RECEIPT DATE: 4-23-15 **ONSITE SEWAGE DISPOSAL SYSTEM** P 555826

PROPERTY ADDRESS: 2791 FLORENCE ROAD, WOODBINE MD 21797

SUBDIVISION: LAYTON KNOLL LOT: 6 TAX ID: 04-596847

SITE PLAN FOR BAT SYSTEM INSTALLATION
LAYTON KNOLL
 LOT 6
 2791 FLORENCE ROAD
 ZONED RC-DEO
 TAX MAP NO.: 7 GRID NO.: 19 PARCEL NO.: 112
 FOURTH ELECTION DISTRICT HOWARD COUNTY, MARYLAND
 SCALE: 1" = 30' DATE: DECEMBER, 2014

HOUSE LOCATION DRAWING

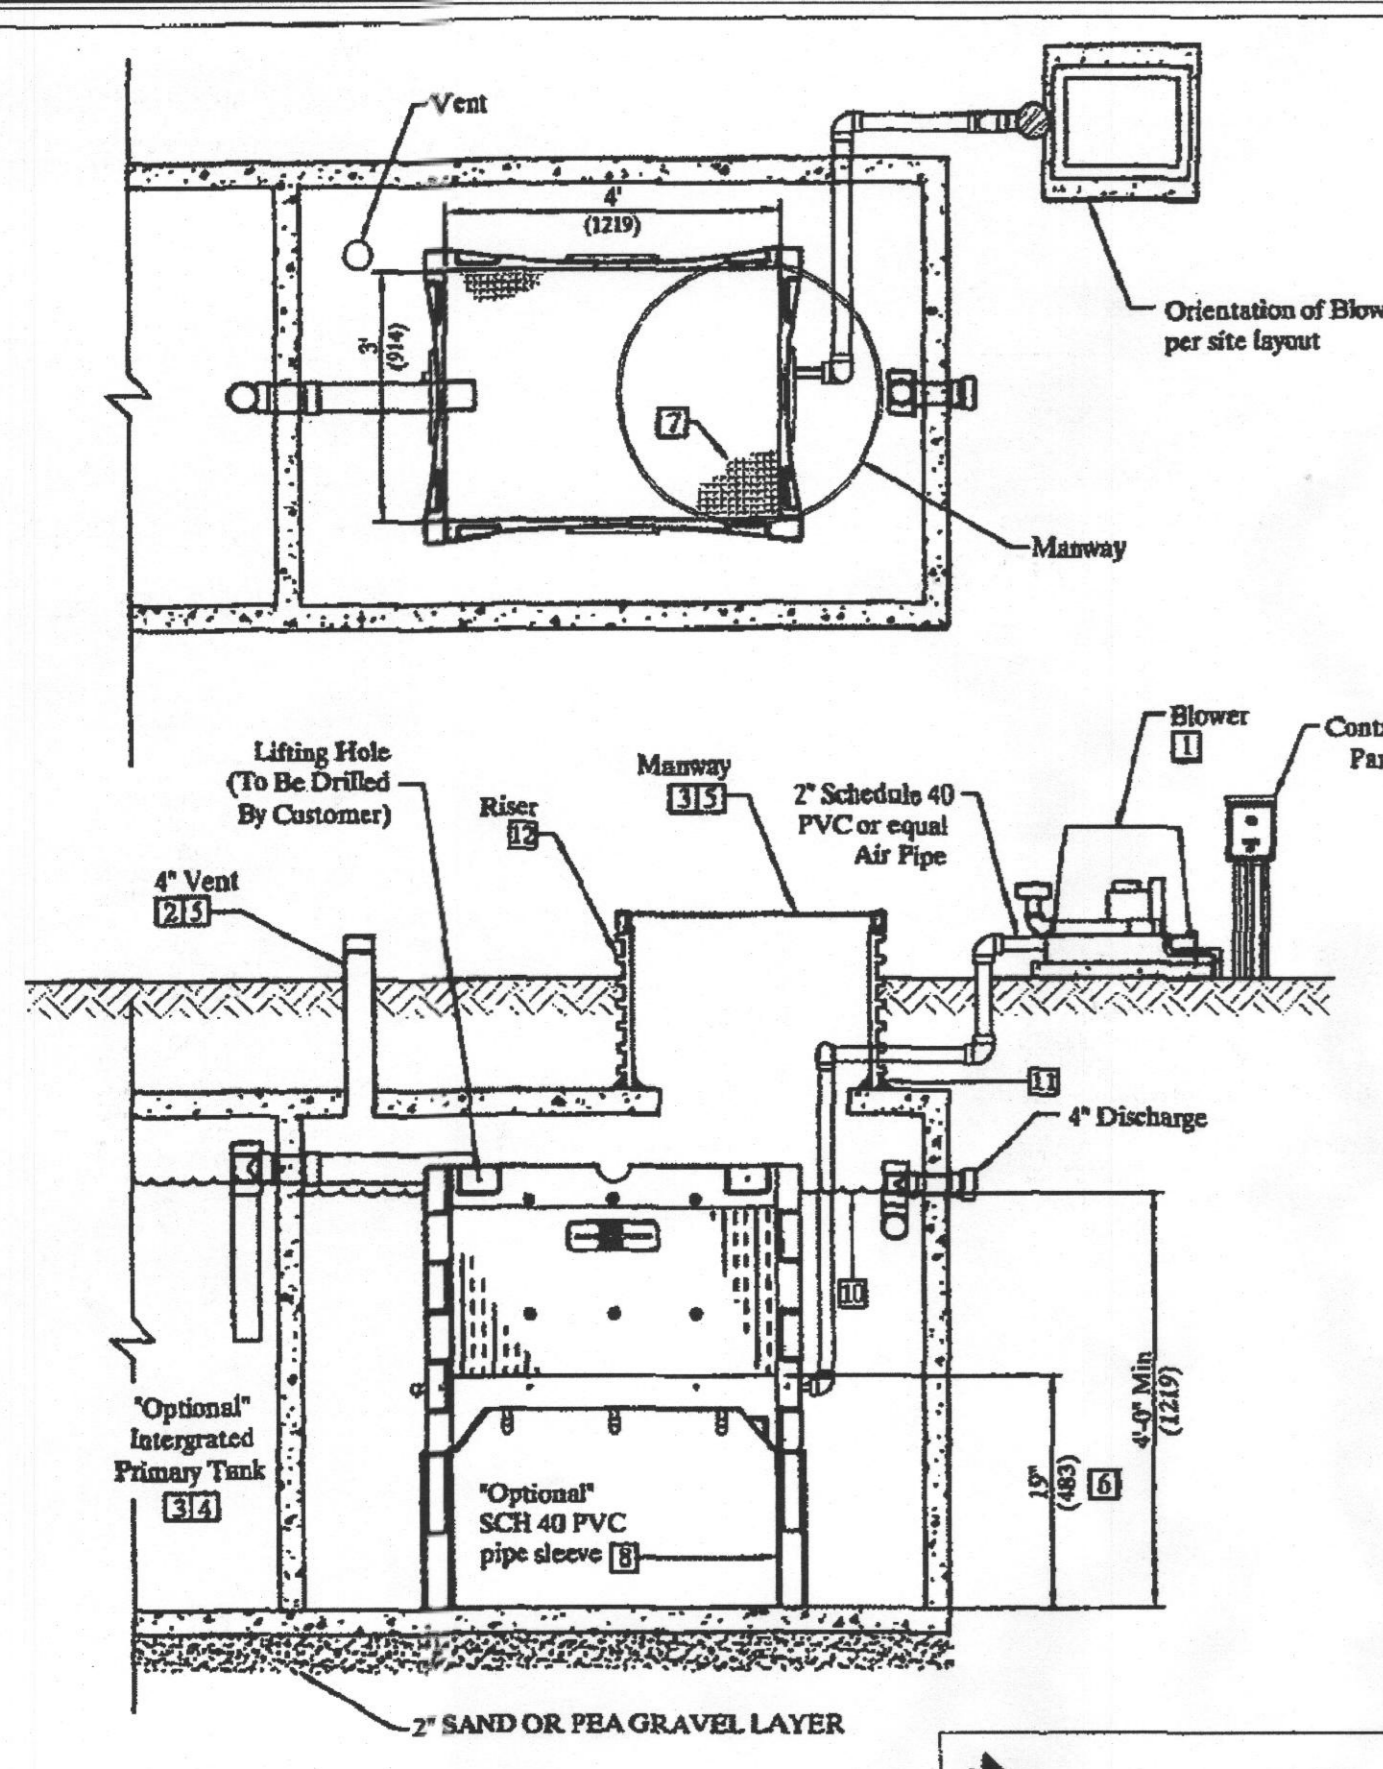
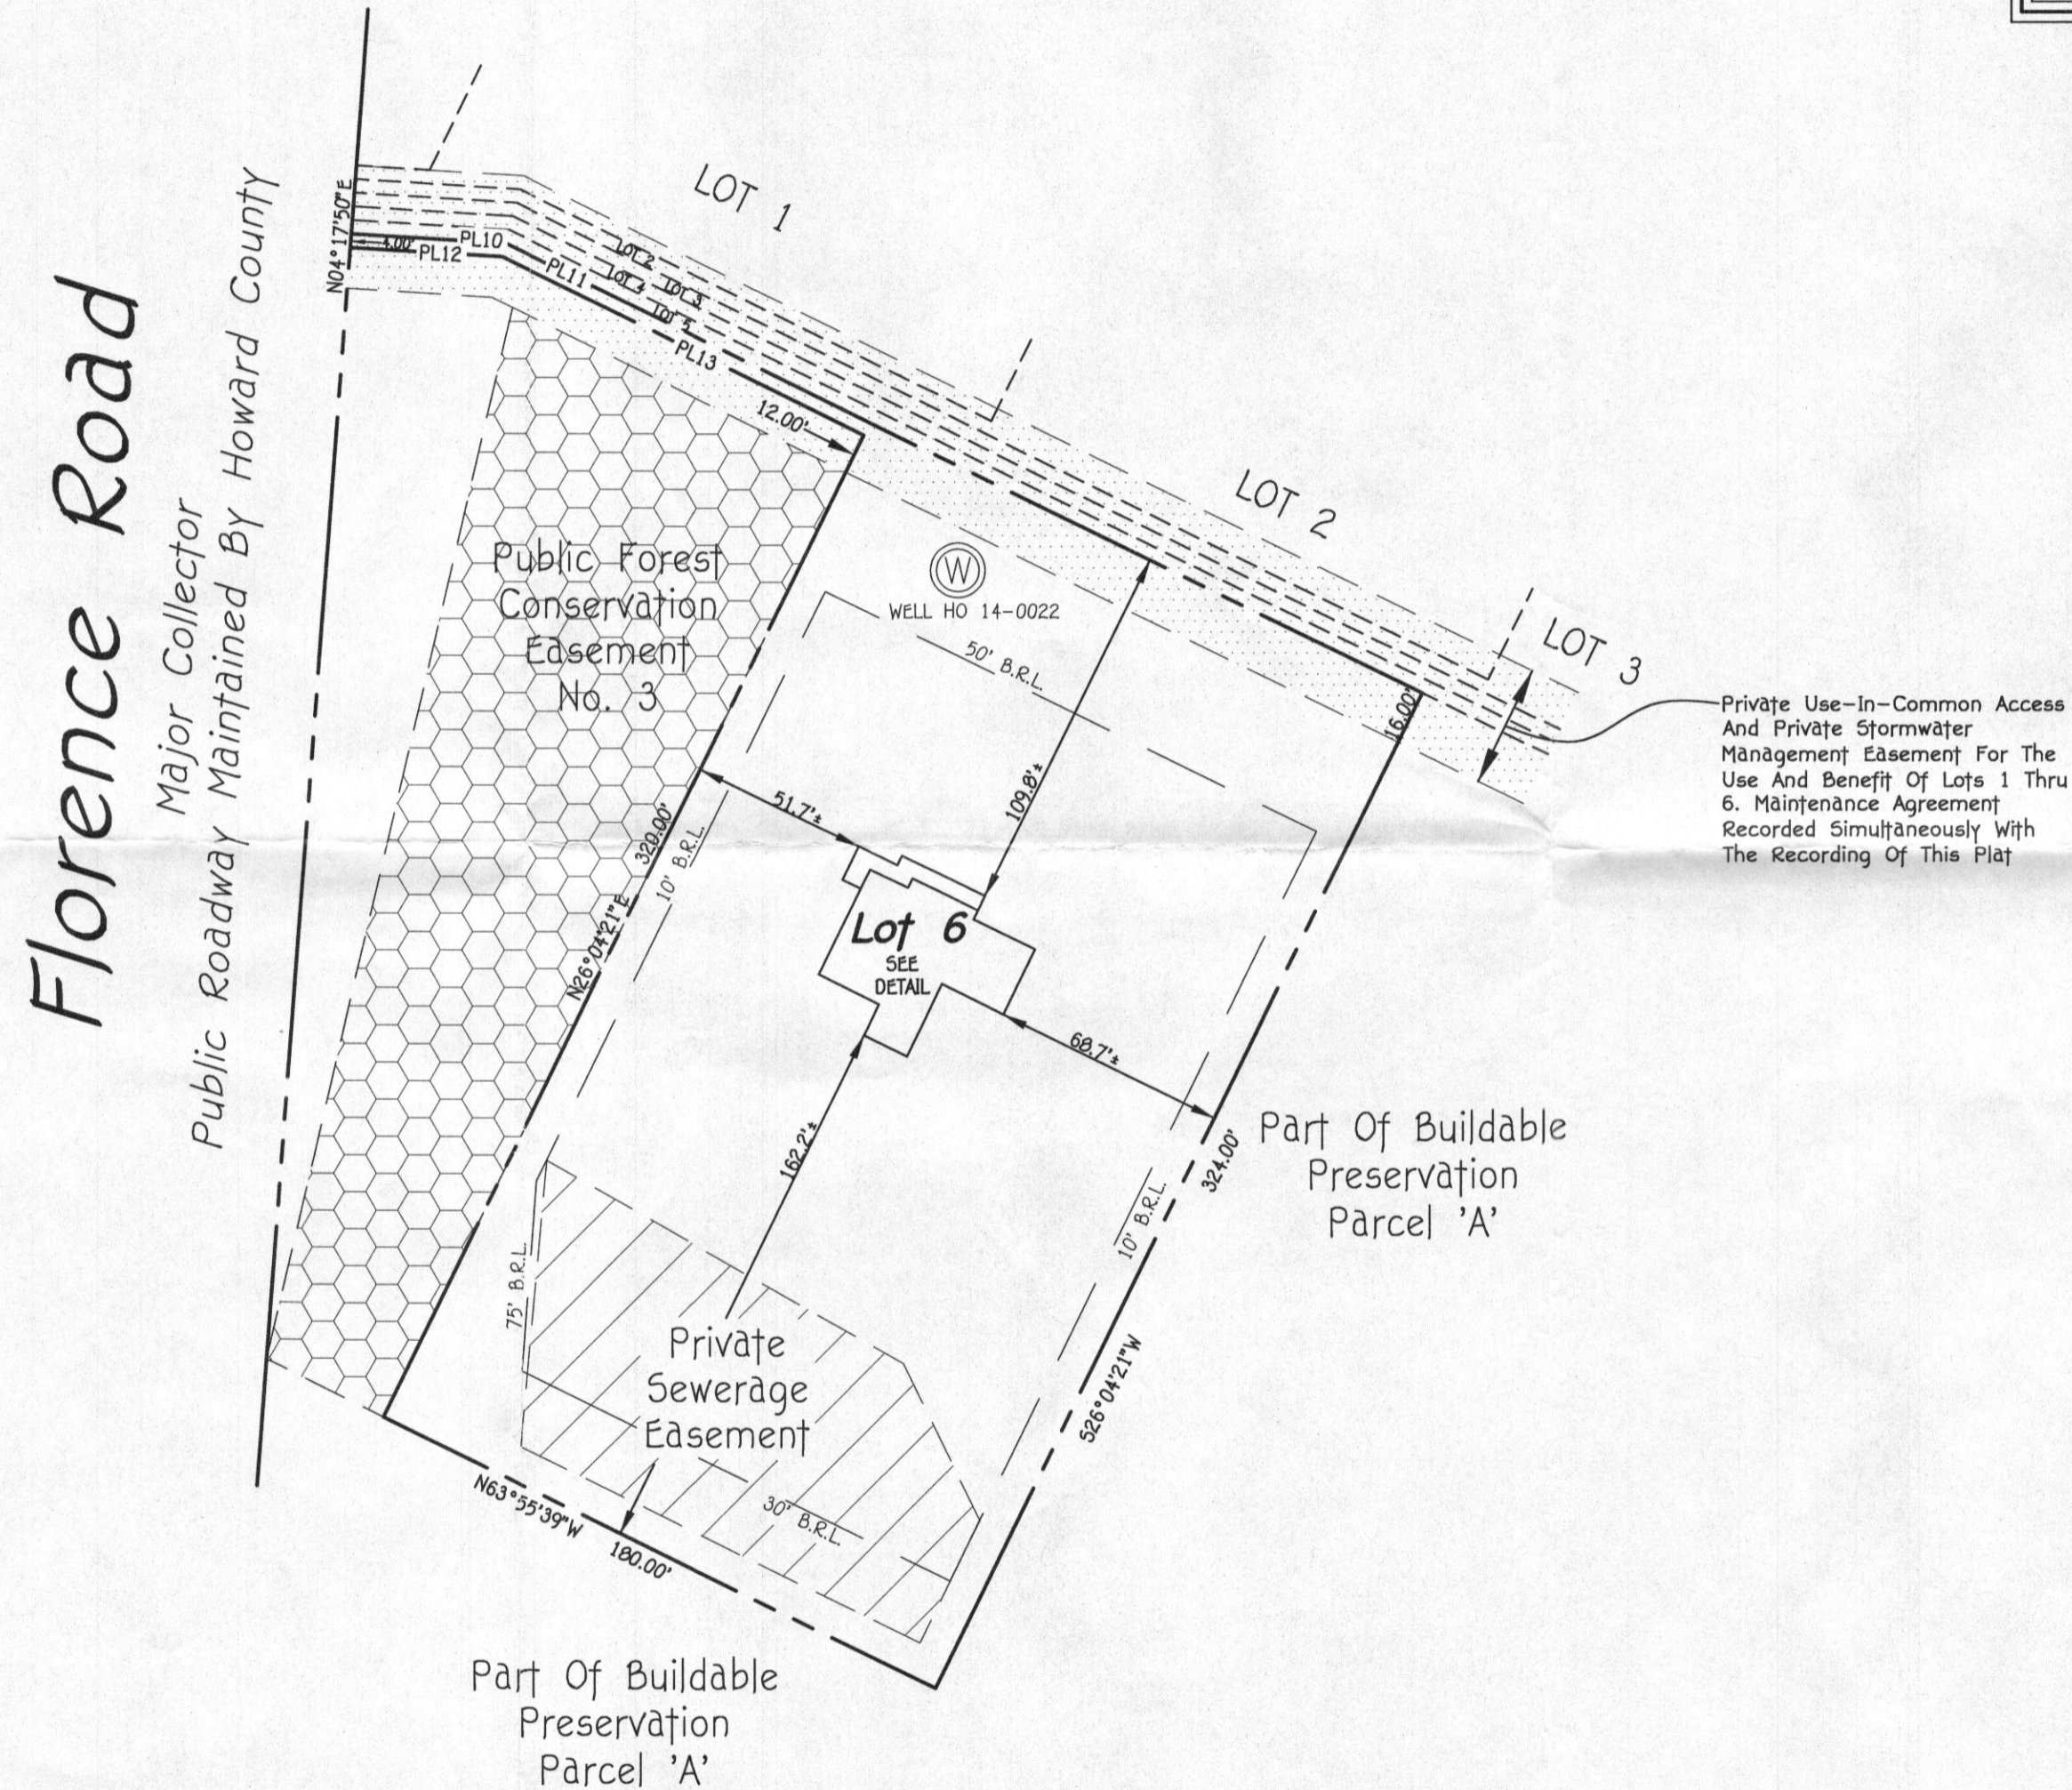
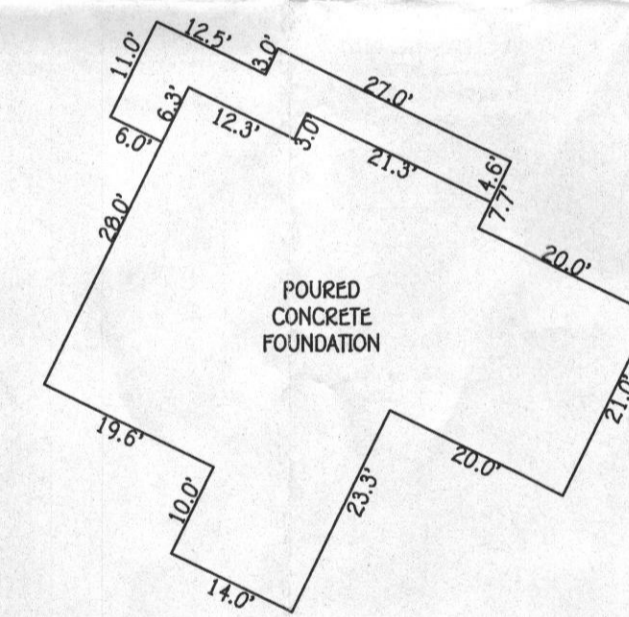
3/10/15.
Informed WTC Builders about ELOPOD moratorium. BAR plan will be revised & submitted for review.
-H.O.

3/10/15-
Well check approved.
-H.O.
